FAIR OAKS RENEWABLE ENERGY PARK

Further Environmental Information - EIA

JUNE 2023

Plate 1 - Extract from ES Figure 9.4a showing location of Viewpoint 10

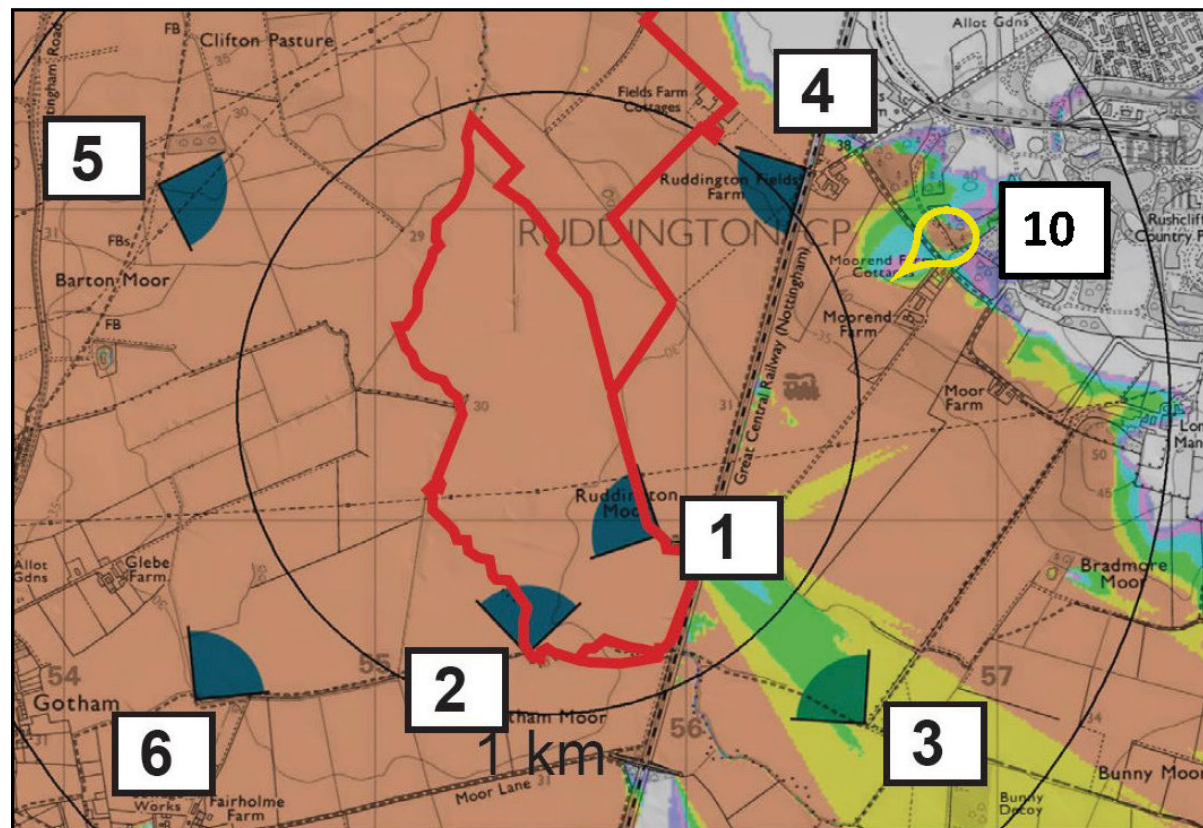
44 Location: this viewpoint is on a circular footpath route within Rushcliffe Country Park near some benches. It represents a 300m section of the route where it emerges from woodland and provides a relatively open view towards the northwest, west and southwest. The footpath is accessible to the public but not part of any long distance or local walking routes within the study area. It is 1.2km to the site perimeter fence and east-northeast of the site centre (see Plate 1).
